2020 Vermont Commercial Building Energy Standard AMENDMENTS

These rules are adopted under 30 V.S.A. § 53. This document shall be known and cited as the *2020 Vermont Commercial Building Energy Standard Amendments*. The *2018 International Energy Conservation Code (IECC)* (First Printing: August 2017) and *ANSI/ASHRAE/IES Standard 90.1-2016 Energy Standard for Buildings Except Low-Rise Residential Buildings* published by International Code Council (ICC), Inc., as amended, are incorporated by reference and are available on the ICC website at: www.iccsafe.org. The IECC is amended herein as follows.

FIGURE C405.2.3.3(4)
DAYLIGHT ZONE ADJACENT TO CLERESTORY FENESTRATION IN A WALL

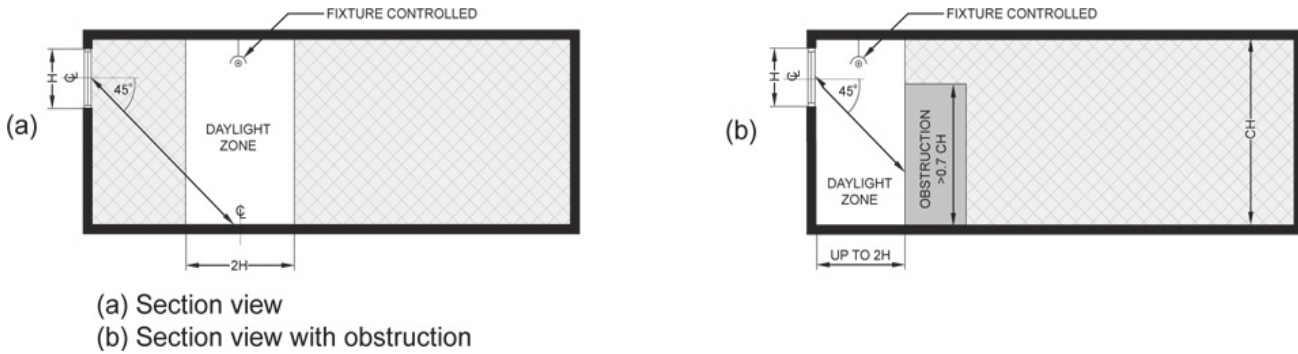
- add - **FIGURE C405.2.3.3(4) DAYLIGHT ZONE ADJACENT TO CLERESTORY FENESTRATION IN A WALL**
